Figure for TPS timer Comment I-72

New figure for TPS timer reset

New Figure 189-5a (after 189-5)

Figure 145–17—PSE MPS monitor state diagram for single-signature PDs or 2-pair operation

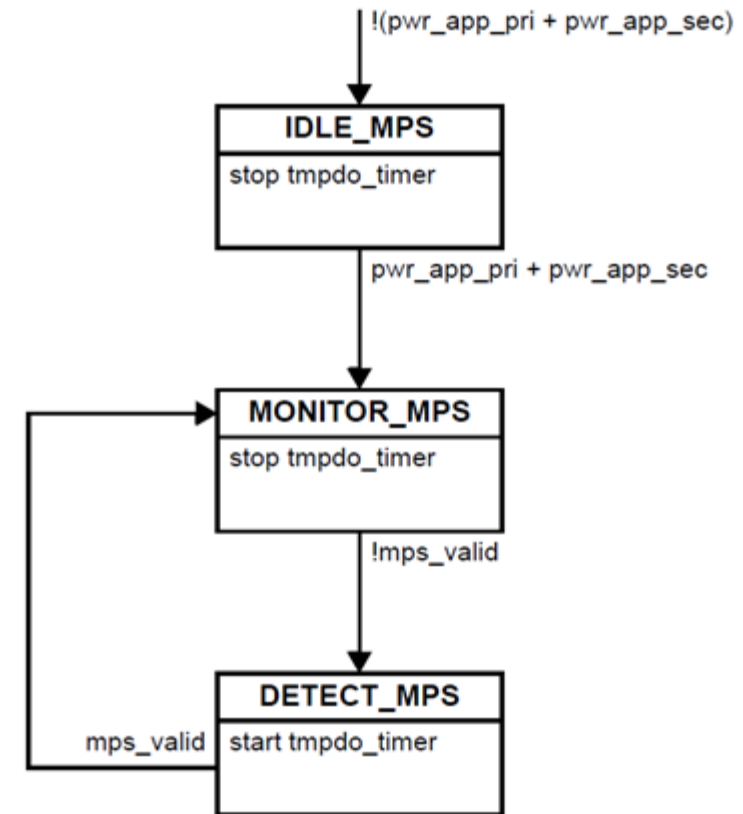
- We would need the equivalent of figure 145-17 (145-18 is for dual-sig PDs which we don't have).
- The feature is called TPS instead of MPS, the timer is already defined in 189.4.4.3 (ttpsdo_timer), as below:
 - ttpsdo_timer A timer used to monitor the dropout of the TPS. See 189.4.10.1 and TTPSDO in Table 189–5.
 - Also, instead of pwr_app_pri + pwr_app_sec in Figure 145-17, we just have one variable: mpi_powered (also defined in 189.4.4.3)
 - Mps_valid is replaced by a newly defined variable

- Add figure to 189.4.4.3 based on figure 145-17 with the following changes:
 - tmpdo_timer becomes ttpdo_timer in all places
 - pwr_app_pri + pwr_app_sec becomes mpi_powered at entry and exit to IDLE_MPS
 - State names become XXX_TPS
- Add new variable tps_valid to 189.4.4.2

tps_valid

A variable used to indicate the presence of at least one MPD requesting power

TRUE: IMPSE is in the range of Ihold

FALSE: IMPSE is less than or equal to IHold min
